ADA Curb Ramp New Construction Inspection Form (Perpendicular)

nw 311 th ave

24952.54

Nw timeric dr

PERPENDICULAR RAMP (PR)

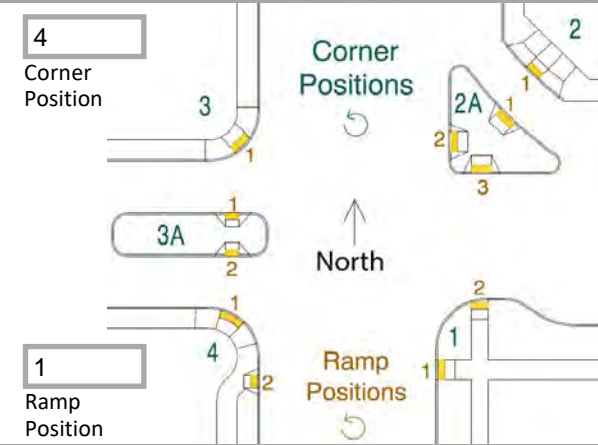
Crack curb an gutter
